STS-109/ET-112 Flight Readiness Review

External Tank Project

February 14, 2001

Overview

**Ullage Pressure Transducers
and Flex Hoses
(LH2 installation shown)**

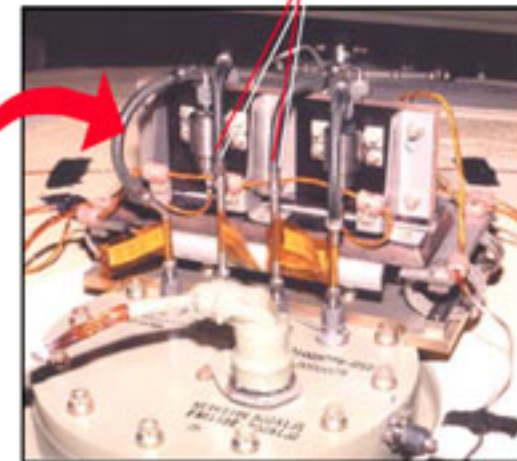
- Revised manufacturing process used to fabricate convoluted Teflon line in LO2 and LH2 ullage pressure transducer flexible hoses
 - No change in material or dimensions - Only convoluting process changed

- Supplier exhausted supply of material and original tooling no longer available
- Hoses are identical in diameter and assembly

- No change in acceptance tests (leakage, burst and x-ray)
- Test - Random and Sinusoidal Vibration
 - Strength – No sign of damage from impact or fatigue
 - Leak – No degradation in the pressure decay
 - New hoses did not alter the response of the isolation platforms

Change Increase LO2 Dome Cap Membrane Thickness

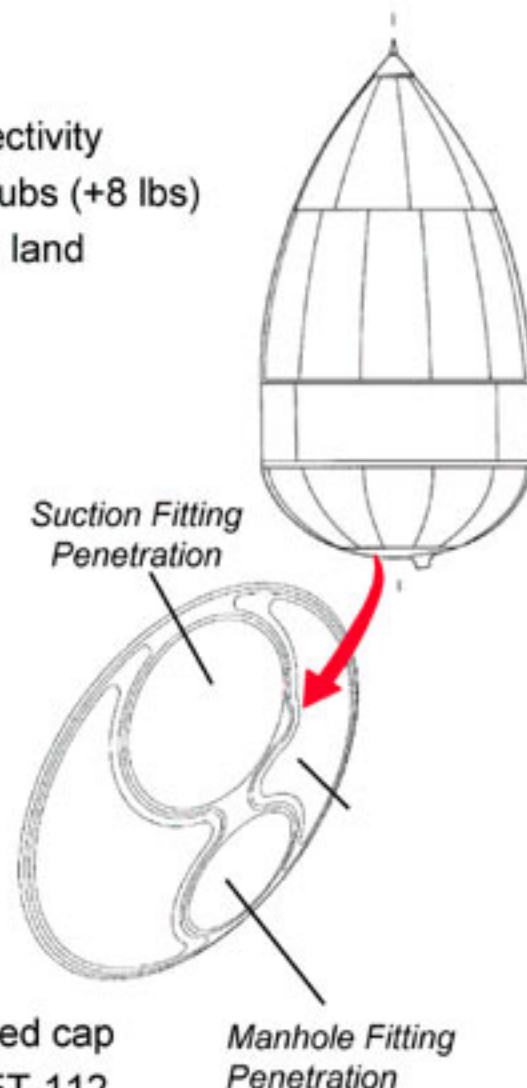
- Reallocated ET-115 LO2 tank dome cap to ET-112 LO2 tank aft dome
 - Reallocation required due to welding issues with dome on earlier effectivity
 - Dome cap acreage membrane thickness increased for ET-115 and subs (+8 lbs)
 - Basic cap design configuration is unchanged (i.e. material, weld land widths, weld land thickness)

- SSP requested External Tank certification to higher maximum LO2 tank ullage pressure operating range (expansion of ICD requirements)
 - ICD pressure increase required to allow the Orbiter fleet to use any combination of spare GO2 fixed orifices beginning at ET-115
- Certification to the higher pressures required increases to the dome cap membrane thickness (LO2 proof test pressures, barrel membrane thickness changes to be discussed at STS-112/ET-115 SSV FRR)

- Test - Proof test demonstrates a minimum of 120% of design limit load
- Analysis - Stress analysis shows improved Factors of Safety for redesigned cap
 - Proof and flight pressure requirements are unchanged for STS-109/ET-112

Change Revise LH2 PAL Ramp Angular Build Dimension

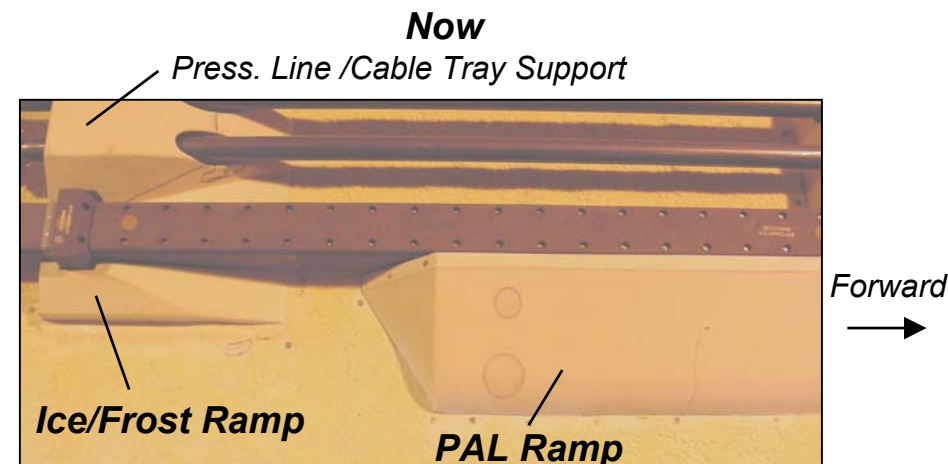
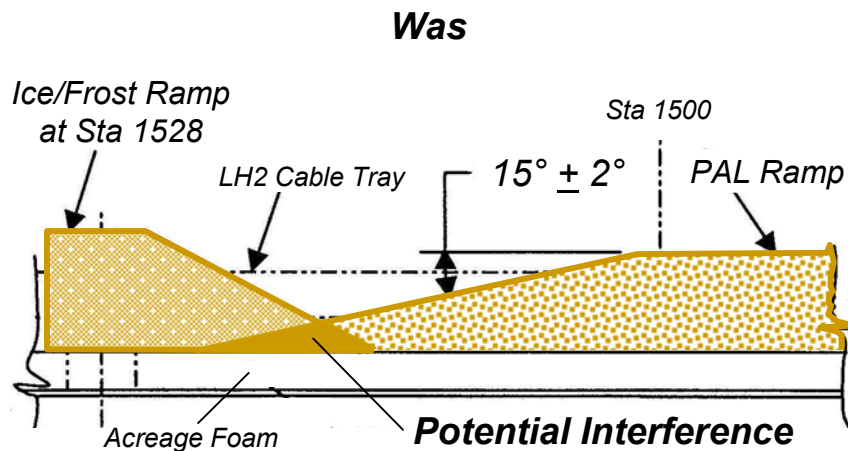
- **Change**
 - Revised ICD / engineering to eliminate potential interference between LH2 PAL (Protuberance Air Load) ramp and the ice/frost ramp
- **Reason for Change**
 - New mold used for ice/frost ramps on LH2 tank ice/frost ramps to reduce acreage foam damage during mold removal
 - Introduction of the new mold identified a potential condition wherein the LH2 PAL ramp if applied to current dimensional requirements could overlay onto the forward surface of the ice/frost ramp at XT1528
 - Potential for interference existed since ET-1
- **Basis for Certification**
 - Analysis - LH2 PAL ramp angular dimension change certified by aero analysis
 - No change to airload methodology

Burst Disc

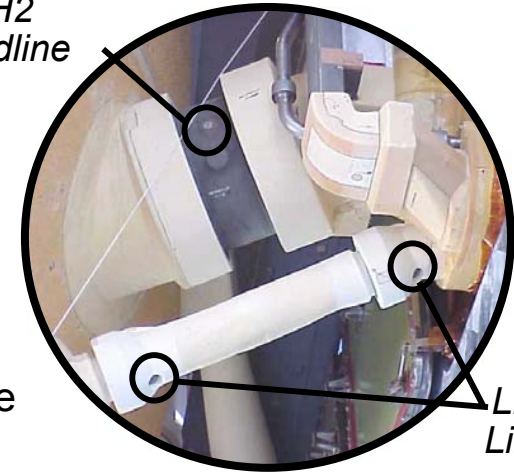
- **Change**
 - Repair suspect burst discs using Conathane primer
- **Reason for Change**
 - During a supplier ATP burst discs leaked
 - Leakage at microscopic cracks observed on the part during failure analysis
 - Cracking observed only on small “bumps” in the center of the disc
- **Basis for Certification**
 - Test
 - Method to repair remaining suspect burst discs using Conathane primer developed and validated
 - Repair prevents leakage of burst disc during operations
 - All materials are approved for use on ET flight hardware
 - Testing demonstrated that Conathane repair does not affect the burst pressure of the disc
 - Repair presented to and approved by PRCB 11/19/2001 (S061766)

Typical Crack
*Approx. 0.008”
in length*

LO2 Feedline Foam Concern

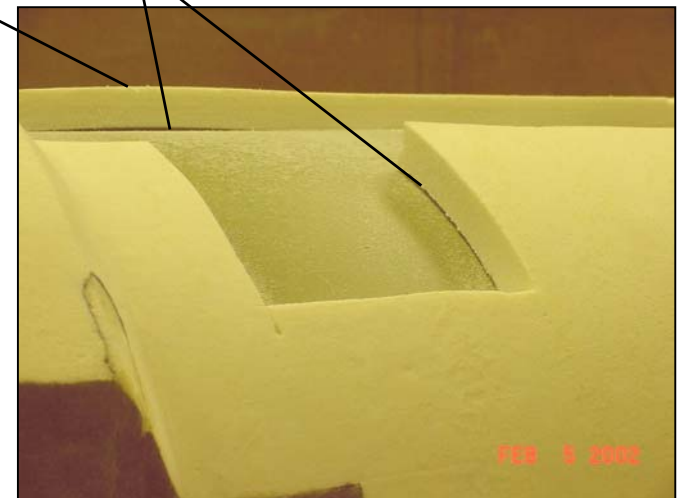
- Suspect foam debond condition exists on one of four straight feedline sections on ET-112/STS-109 (Sta 1623 to Sta 1871)
 - This is the first line section to be sprayed with BX-250 after phase out of SS-1171 (October 2000)

- During foam closeout of the ET-118 LO2 feedline at MAF, the technician visually noticed a “bump” in the foam approximately 17 in. long and 360° around circumference of the 20 ft long line
- Suspect condition has been isolated to lines with BX-250 foam and to the area at forward end of straight feedline sections near support brackets
 - This area has a thicker initial layer of foam due to the spray start-up process
 - Evidence of distorted foam cells from adverse flow of blowing agent was observed

*Visual “bump”
 in foam*

Debond (after section removed)

Note: Thin foam film remained on substrate indicating no substrate contamination

Support
Brackets

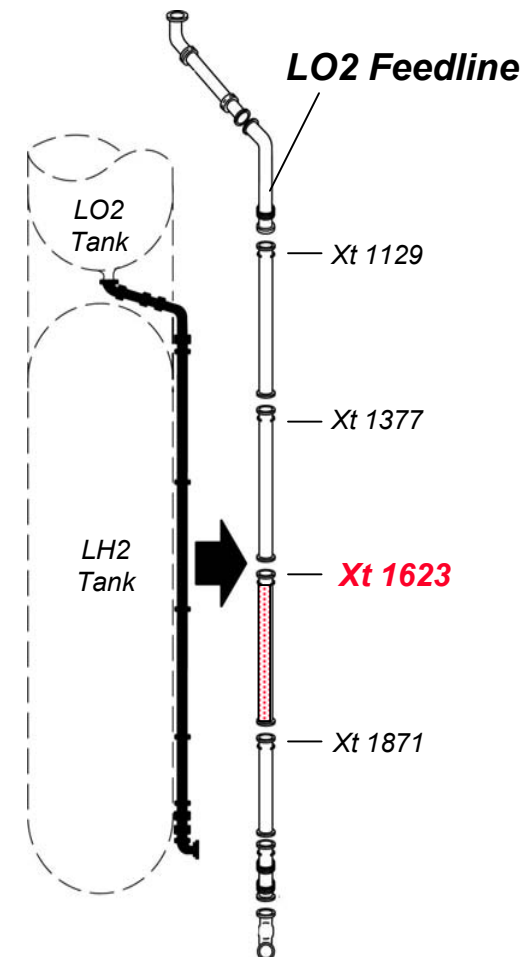
- Knit line analysis of removed foam showed that initial layer of foam (applied prior to start of carriage travel) was inordinately thick ($\approx 0.75"$)
 - BX-250 provides better mechanical properties when initial layer of foam is thinner ($0.25"$)
 - SS-1171 produces better mechanical properties when initial layer of foam is thicker ($0.50"$)
- Plug pulls performed on lines with SS-1171 foam confirm that debond condition is isolated to BX-250 sprayed lines
- Problem isolated to foam bond/adhesion only
 - ET-118 foam which essentially had no adhesive bond strength and foam was removed and tested to evaluate foam integrity
 - Foam cohesive strength exceeded design requirements and the values are consistent with typical BX-250 foam
- No concern for other BX-250 foam applications on the ET due to process and location
- Feedline is only semi-automated process
